NASA/CP-2003-212164

# Avionic Pictorial Tunnel-/Pathway-/Highway- In-The-Sky Workshops

*Russell V. Parrish, Compiler*  
*Langley Research Center, Hampton, Virginia*

Figure 2a.

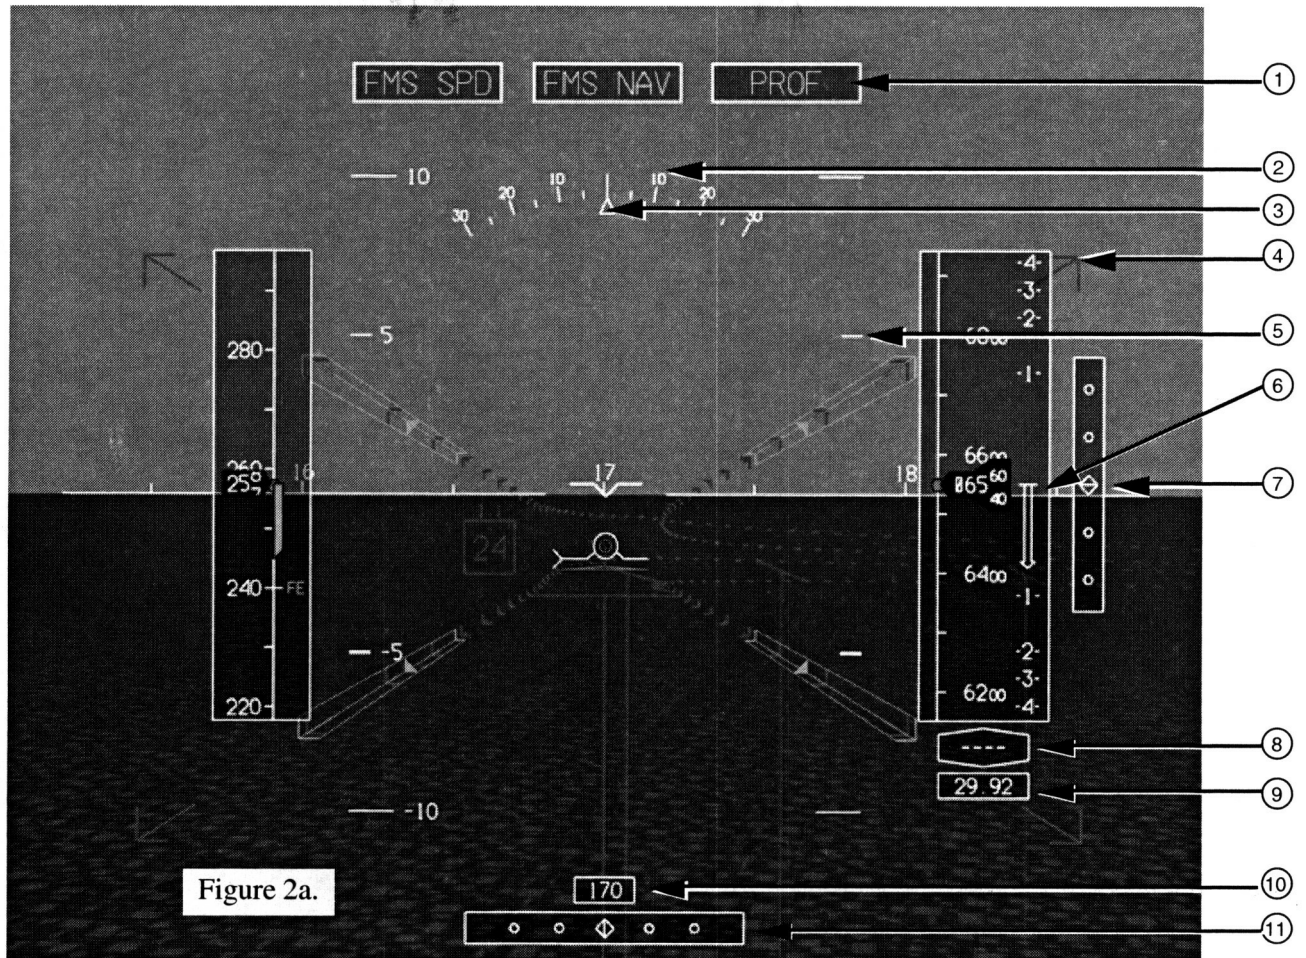
- Several initial types of flight path “tunnels” were reviewed. The Dorigi Tunnel is defined by four dotted lines at the edge of an acceptable error box, with square guidance symbols inside the dotted lines, and a reference solid box at a fixed time reference ahead of the aircraft. The “Noodle Tunnel” is defined by a series of boxes, leading from the present aircraft position to a reference position on the cleared path, or final approach fix. The NASA Langley Goal Post Tunnel is defined by partial boxes consisting of side and bottom segments, center pillars extending from the bottom of the boxes to the terrain floor, and rectangular tiles inside the boxes defining the path to be flown.<sup>1</sup>

position, this tunnel provided no cues to path error, merely showing a route back to the desired path.<sup>1</sup>

- A discussion occurred on whether to provide a pathway display element during constant heading flight modes or during cruise modes in general. This evolved into a discussion, again, on what constitutes a pathway. The consensus among the group was that a pathway is a defined three dimensional line in space, consisting of curved and/or straight segments, over fixed earth-referenced coordinates. Pathways could also have a time critical dimension associated with them, during 4-D clearances. This definition is consistent with what is presented on FMS map displays in current aircraft. Constant heading modes may not fit this definition. It was suggested that pathways not routinely be displayed in constant heading modes due to difficulties in display or interpretation of lateral flight path errors. It was also suggested that pathways, in general, be a pilot selectable display element, so that they could be removed in situations where they would be confusing or clutter the display.<sup>1</sup>

Figure 2b.

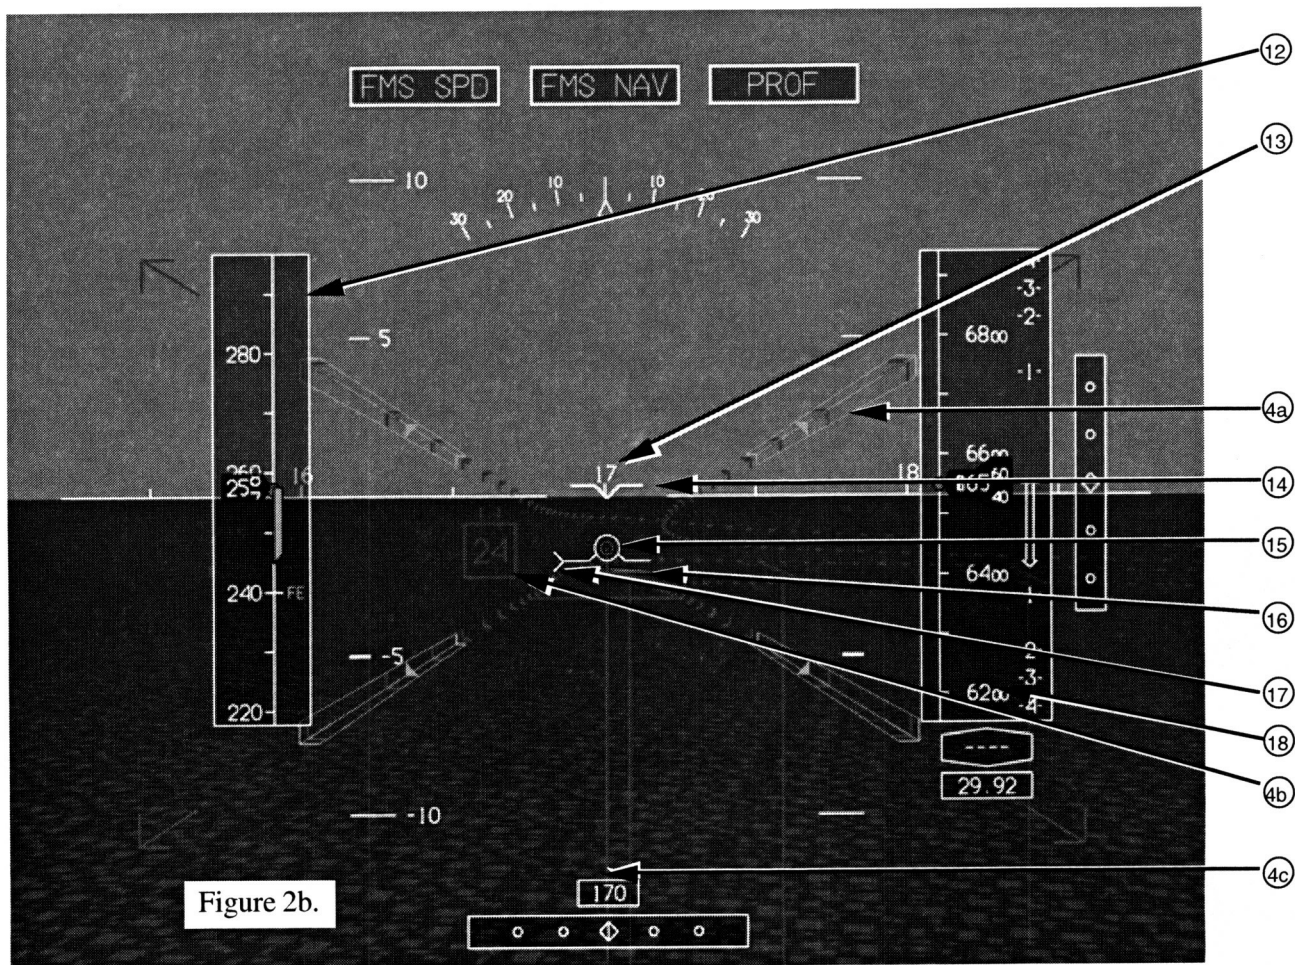
- A pathway is not appropriate for all cases; a pathway is "attached to the earth" in normal viewpoint so doesn't work for heading hold, performance climb or descent, etc., which are not tied specifically to the earth although they may have to be accomplished in some volume constraints.<sup>4</sup>

- There may be a need, in presenting pathways, of distinguishing cleared flight paths from expected flight paths.<sup>1</sup>
- The need to show missed approach information was discussed. During approaches, the pilot will need this information both to help plan for flight path requirements and to visualize the projected flight path with respect to terrain, other waypoints, airport references, etc., in the event of a missed approach.<sup>1</sup>

- The need for color standardization in display elements was discussed. Cleared flight paths, for example, are traditionally displayed in magenta on FMS map displays, and should probably be displayed in that color on pictorial displays. Proposed or alternate flight paths could be displayed in white, color intensity, dotted lines, or suppressed resolution to distinguish them as planned paths, on pictorial displays.<sup>1</sup>

- The problem of indicating cleared versus planned altitudes was mentioned. For example, a descent route segment may begin at Flight Level 350 and end at 5000 feet MSL, but the aircraft is only presently cleared 15,000 feet MSL. One method suggested of indicating this in path data was to present a pseudo cloud deck, or translucent tiles, at the cleared altitude on the display. Further study is warranted to arrive at an acceptable method of display.<sup>1</sup>

- Angle irons on the front portion of the tunnel are used to show the status of the time requirement. The symbol represents a 4 second interval; the small right-angle pointer in middle indicates exactly on time. The symbol is normally amber with the right-angle in green; the symbol turns yellow if the right-angle pointer leaves the symbol but is between 4 and 6 seconds off and turns red if pointer is more than 6 seconds off.<sup>4</sup>

- The right-angle pointer symbol limits for being ahead-of-time, but drops behind the angle irons for being behind-time. A suggested modification was to limit the pointer symbol in both directions and to display time error digitally while limited.<sup>4</sup>

- Several of the pilots objected to the amount of clutter, particularly early in the approach, where numerous goal posts could be seen.<sup>1</sup>
- When the pathway is shown overlaid on a video background, the goal post may project to the nominal geometric plane of a flat earth despite the presence of rough and perhaps mountainous terrain. Adjusting the height of the goal posts so that they intersect the real earth volumes present in the video image may be difficult to do and certainly implies an elevation database or dynamic means of estimating elevation in real time.<sup>3</sup>

**Figure 1. XVS Workshop Minimal HUD**

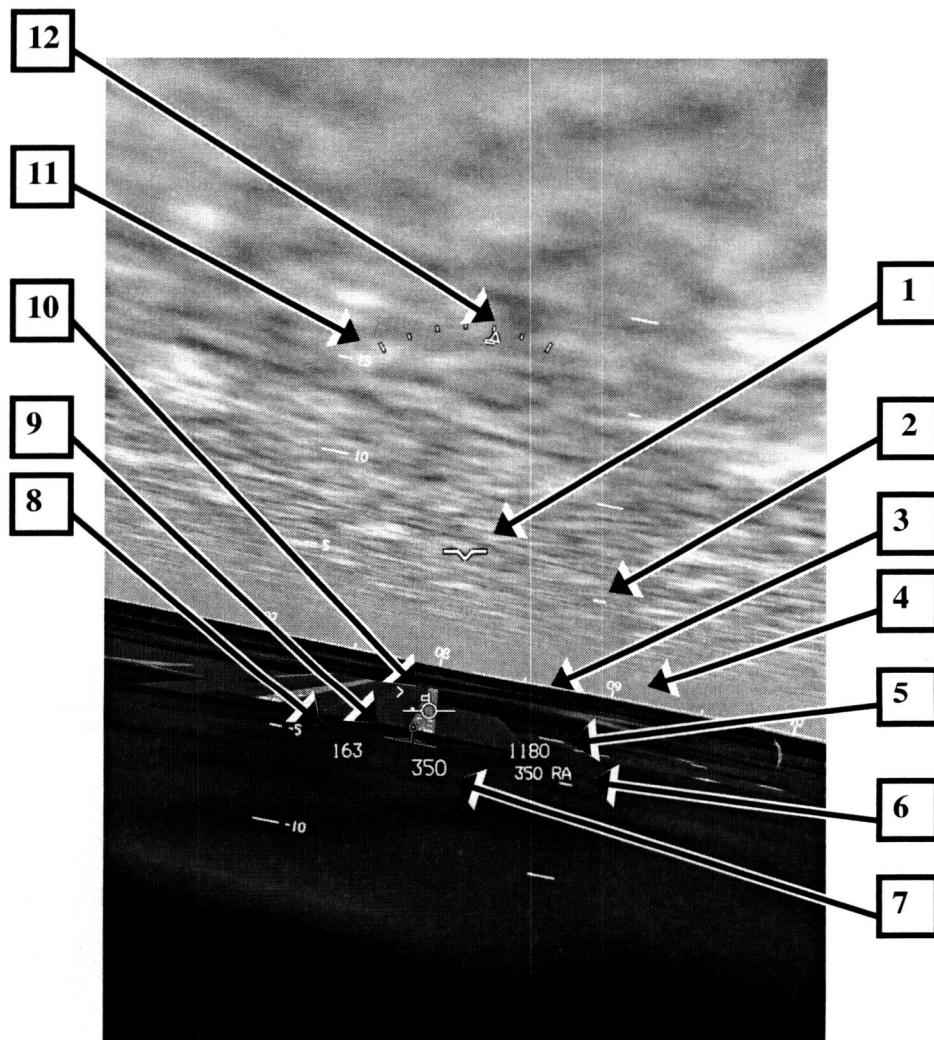
Along the horizon line (element 3), there are compass ticks every 5 degrees. Every ten degree tick is labeled. The 5 degree ticks are 0.3 degrees tall and the 10 degree ticks are 0.4 degrees tall. The heading numbers are centered above the ticks and are 0.5 degrees in height. Heading numbers and ticks are clipped out of (not drawn) in a region that is  $\pm 1.0$  degree on either side of the center of the horizon line gap (element 3). NOTE: The 80 degree heading indication and tick mark in Figure 1 are incorrectly displayed.

**Figure 2. XVS Workshop Minimal HUD**

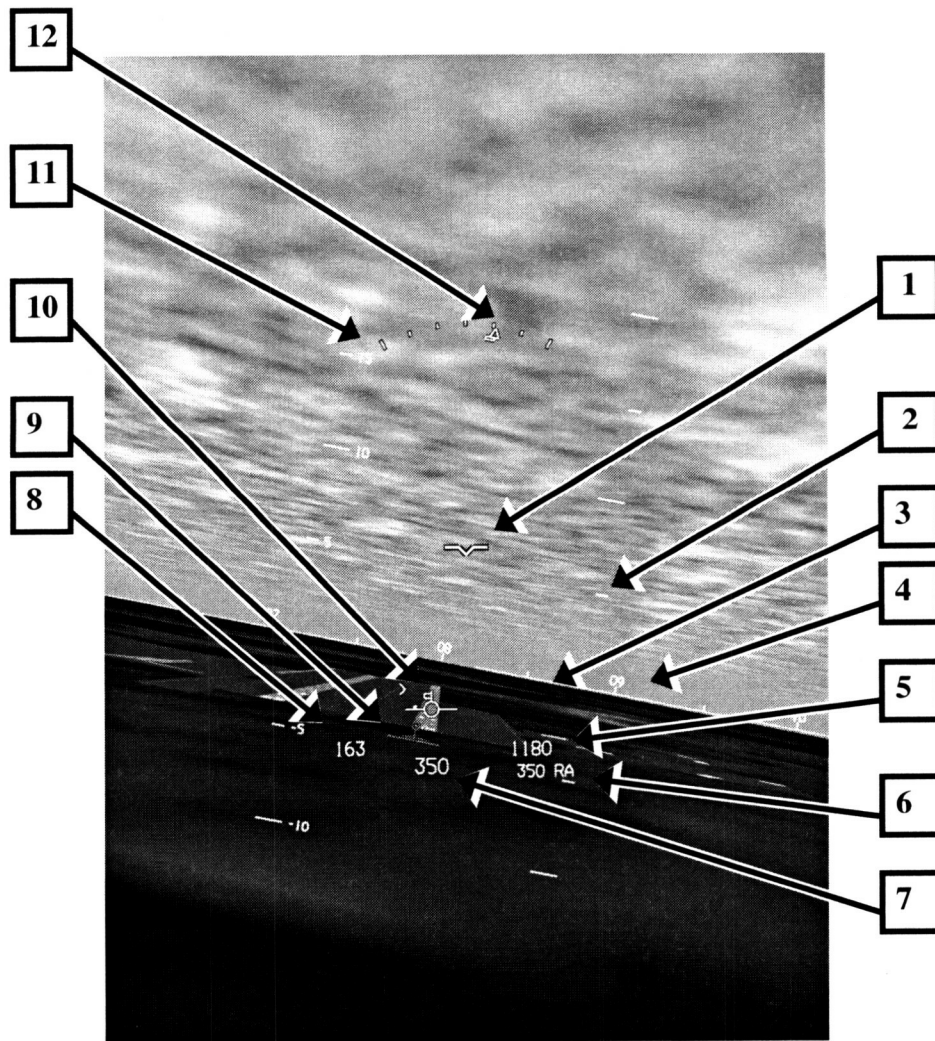
Along the horizon line (element 3), there are compass ticks every 5 degrees. Every ten degree tick is labeled. The 5 degree ticks are 0.3 degrees tall and the 10 degree ticks are 0.4 degrees tall. The heading numbers are centered above the ticks and are 0.5 degrees in height. Heading numbers and ticks are clipped out of (not drawn) in a region that is  $\pm 1.0$  degree on either side of the center of the horizon line gap (element 3). NOTE: The 80 degree heading indication and tick mark in Figure 1 are incorrectly displayed.

Modifications to this minimal symbolgy set for the TIFS.3/FL4 flight test are presented in the following. In addition, elements 13 through 17 have been added to the minimal symbolgy set but are not shown on Figure 1.
